Re: Oconee Nuclear Station
Docket Nos. 50-269, -270, -287

In response to the March 31, 1975 letter from Mr. Karl R. Goller, Duke Power Company submits the following proposed Technical Specification changes for the Oconee Nuclear Station.

The proposed revisions apply to Specifications 3.1.3.5, 3.5.2.3, and 3.5.2.5. The revision to Specification 3.1.3.5 incorporates an additional restriction on the regulating control rod positions prior to criticality to assure that the ejected rod worth does not exceed the 1.0% $\Delta k/k$ limit at hot zero power. The revision to Specification 3.5.2.3 deletes the specification on inserted control rod worths but at the same time specifies the manner in which the inserted control rod worths are to be maintained within acceptable limits. Finally, the revision to Specification 3.5.2.5 modifies the rod withdrawal limits for Oconee Units 2 and 3 after the control rod interchange.

UNIT 2
OCONEE NUCLEAR STATION
Figure 3.5.2-1B1

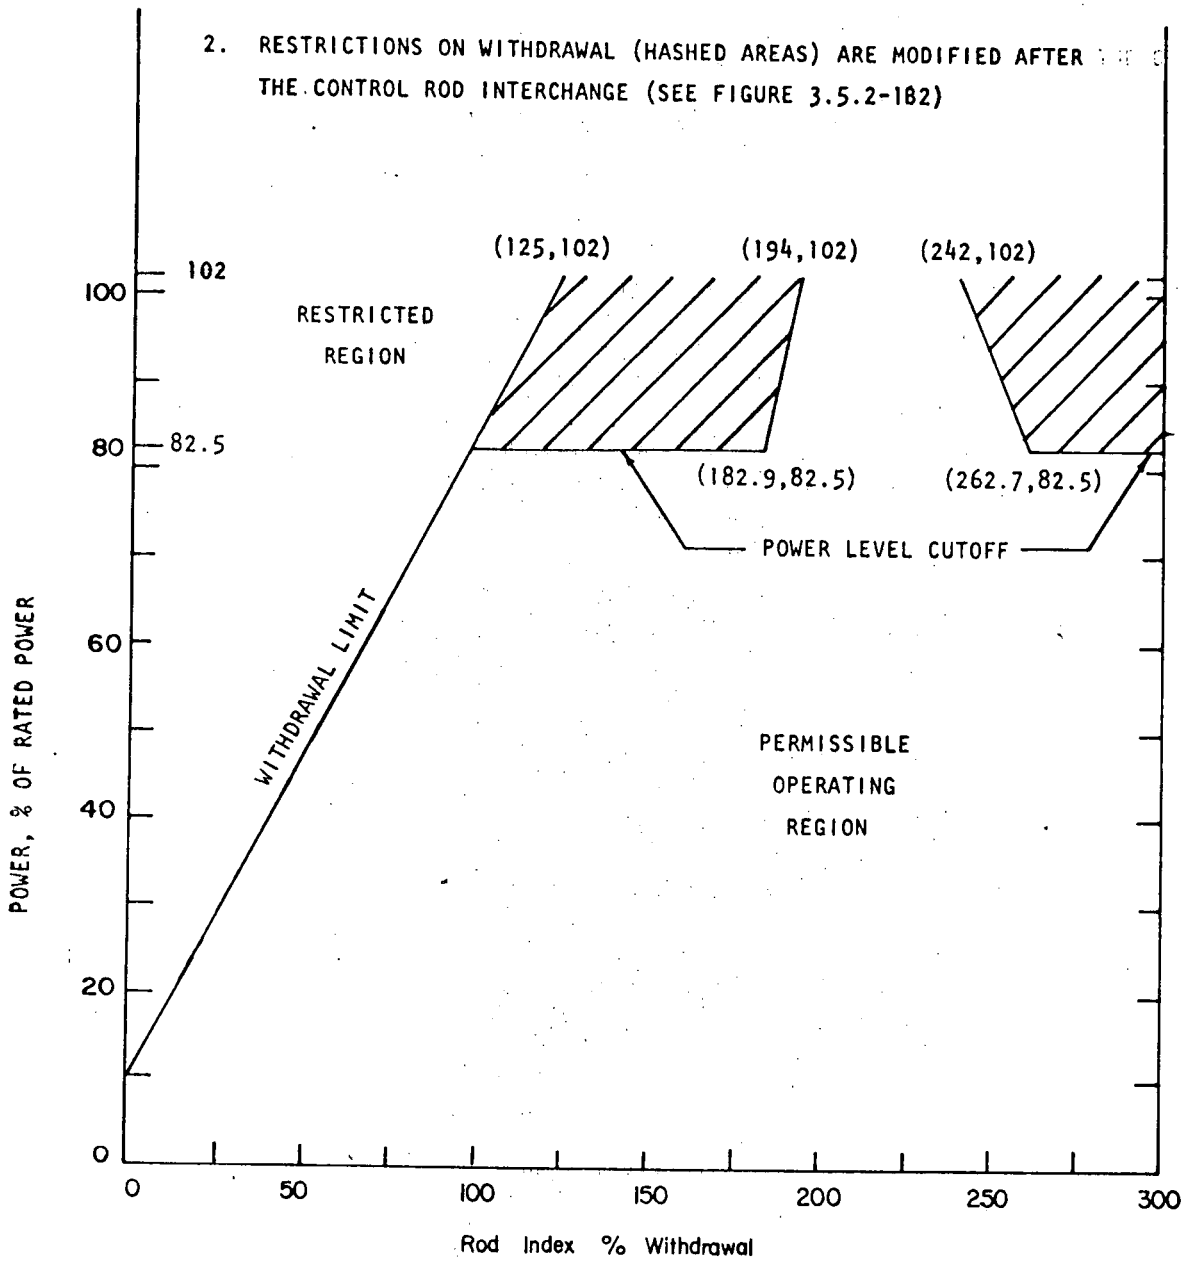
2. RESTRICTIONS ON WITHDRAWAL (HASHED AREAS) ARE MODIFIED AFTER THE CONTROL ROD INTERCHANGE (SEE FIGURE 3.5.2-1B2)

UNIT 2
 OCONEE NUCLEAR STATION
 Figure 3.5.2-1B2

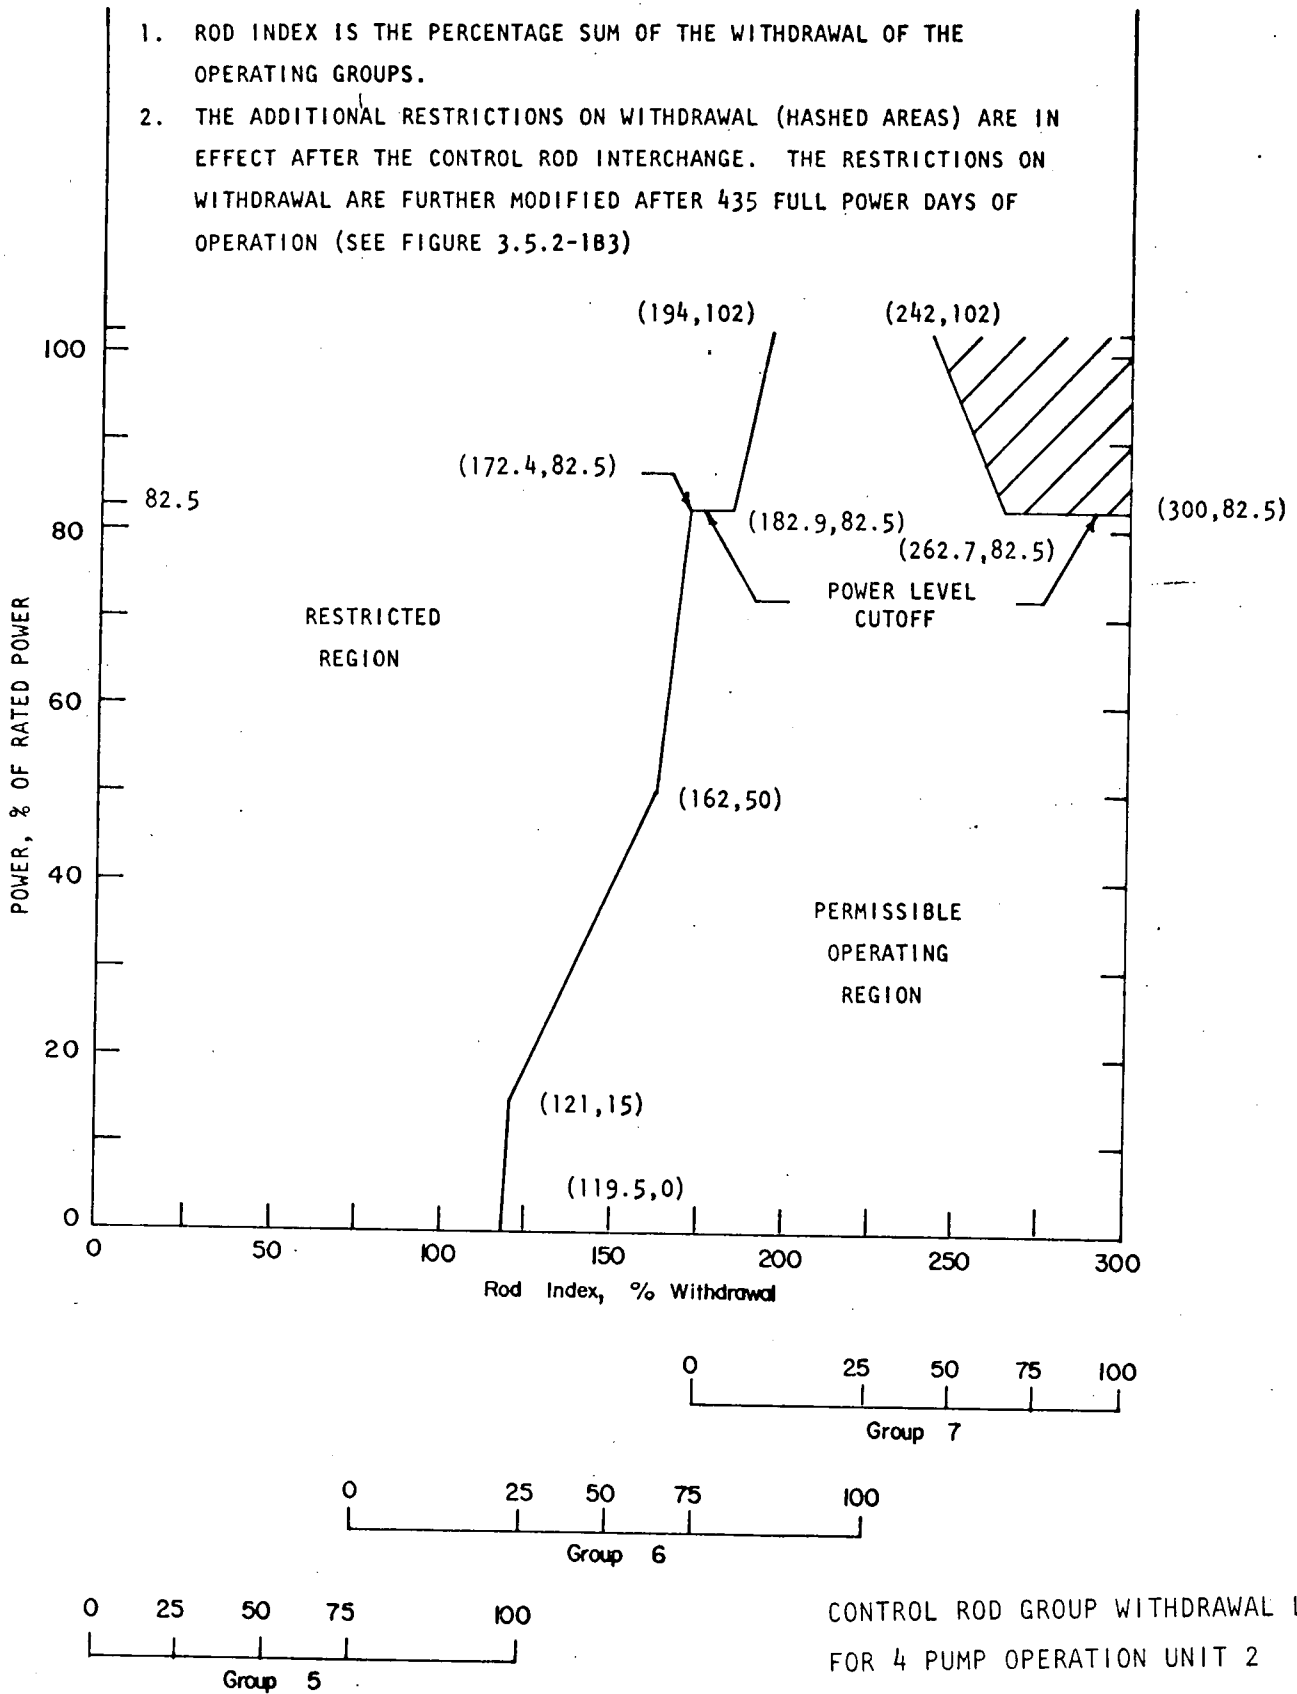
1. ROD INDEX IS THE PERCENTAGE SUM OF THE WITHDRAWAL OF THE OPERATING GROUPS.
2. THE ADDITIONAL RESTRICTIONS ON WITHDRAWAL (HASHED AREAS) ARE IN EFFECT AFTER THE CONTROL ROD INTERCHANGE. THE RESTRICTIONS ON WITHDRAWAL ARE FURTHER MODIFIED AFTER 435 FULL POWER DAYS OF OPERATION (SEE FIGURE 3.5.2-1B3)

Figure 3.5.2-1B3

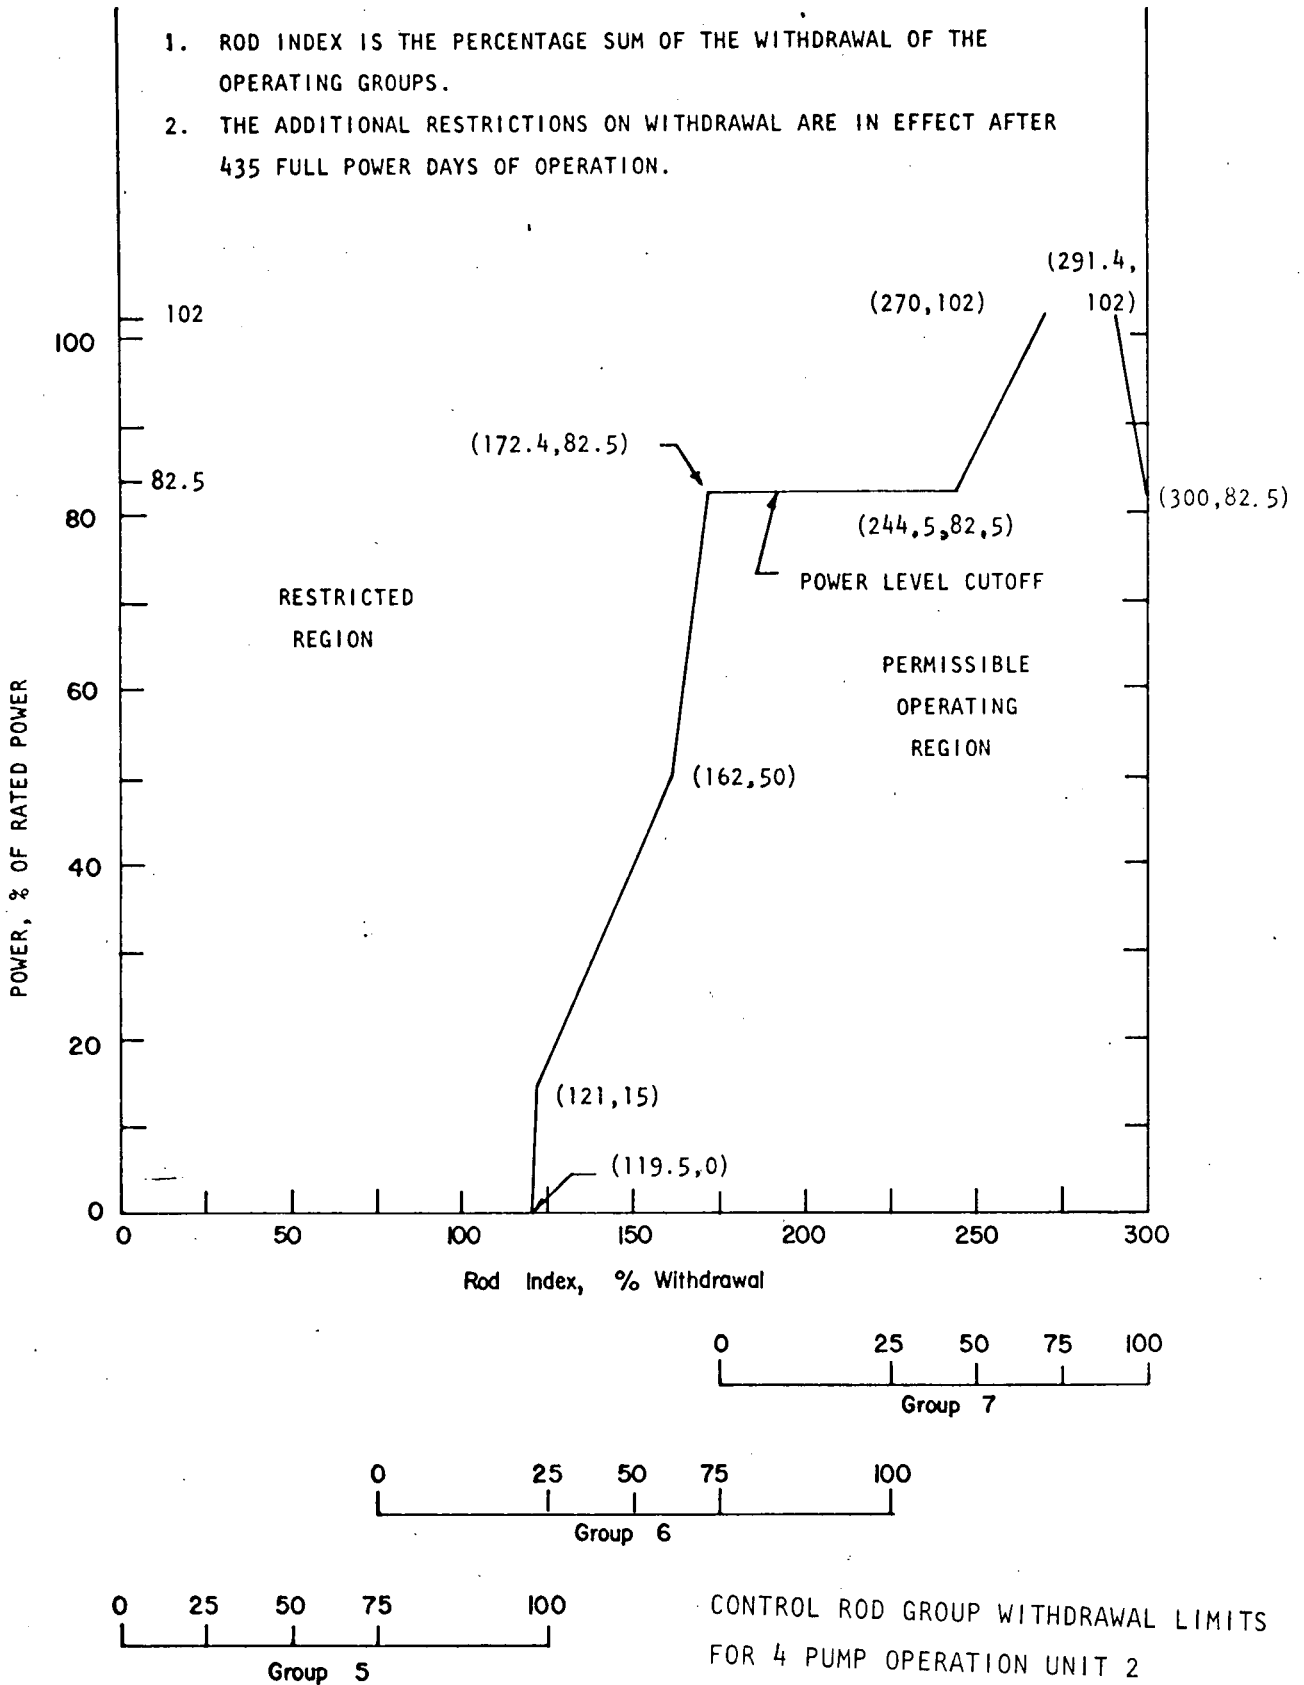
1. ROD INDEX IS THE PERCENTAGE SUM OF THE WITHDRAWAL OF THE OPERATING GROUPS.
2. THE ADDITIONAL RESTRICTIONS ON WITHDRAWAL ARE IN EFFECT AFTER 435 FULL POWER DAYS OF OPERATION.

Figure 3.5.2-1C1

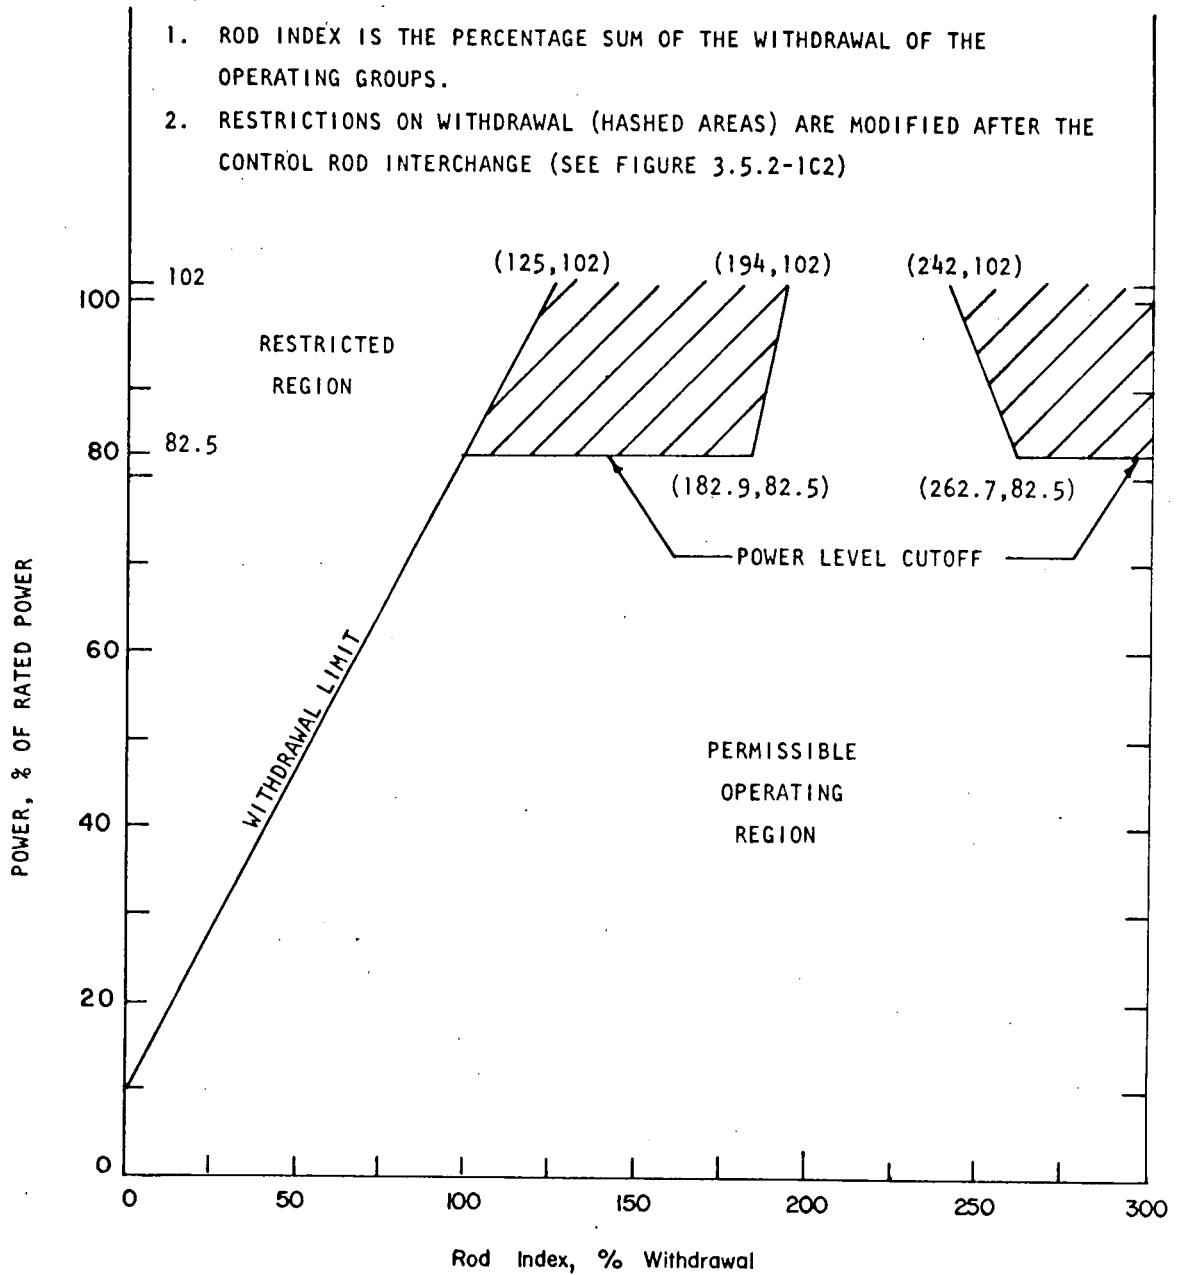
1. ROD INDEX IS THE PERCENTAGE SUM OF THE WITHDRAWAL OF THE OPERATING GROUPS.
2. RESTRICTIONS ON WITHDRAWAL (HASHED AREAS) ARE MODIFIED AFTER THE CONTROL ROD INTERCHANGE (SEE FIGURE 3.5.2-1C2)

UNIT 3
 OCONEE NUCLEAR STATION
 Figure 3.5.2-1C2

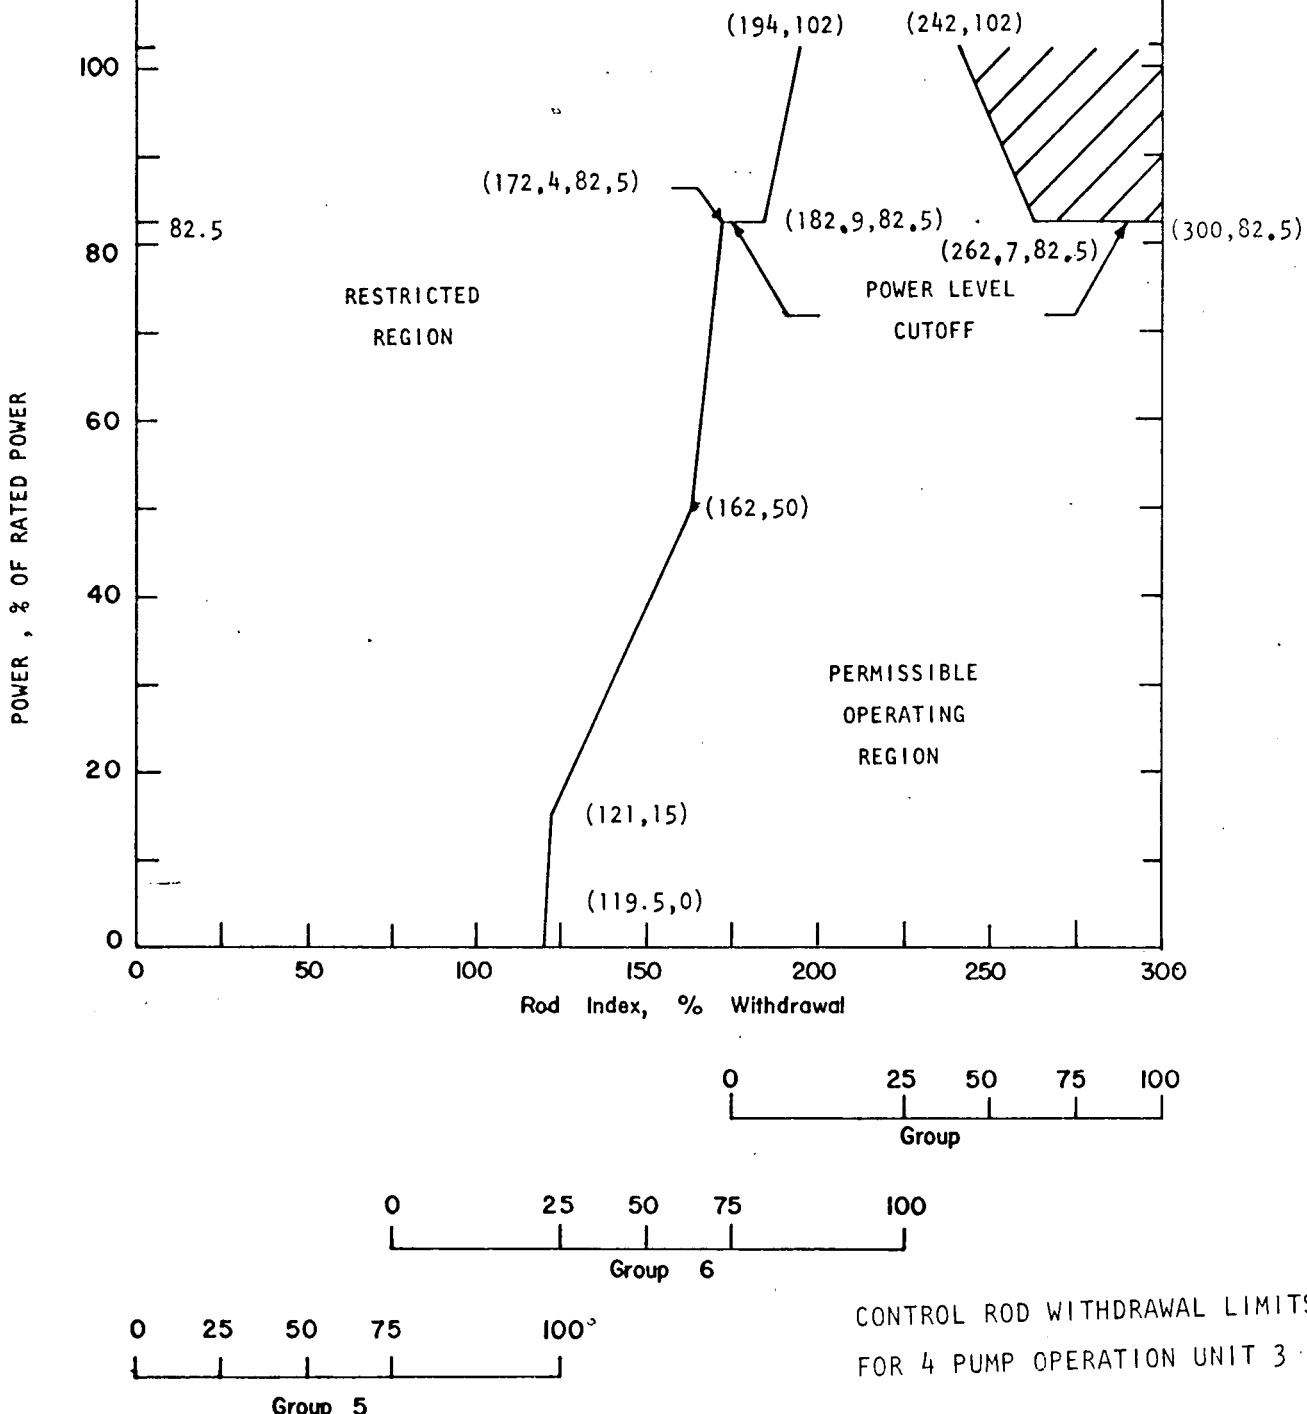
1. ROD INDEX IS THE PERCENTAGE SUM OF THE WITHDRAWAL OF THE OPERATING GROUPS.
2. THE ADDITIONAL RESTRICTIONS ON WITHDRAWAL (HASHED AREAS) ARE IN EFFECT AFTER THE CONTROL ROD INTERCHANGE. THE RESTRICTIONS ON WITHDRAWAL ARE FURTHER MODIFIED AFTER 435 FULL POWER DAYS OF OPERATION (SEE FIGURE 3.5.2-1C3)
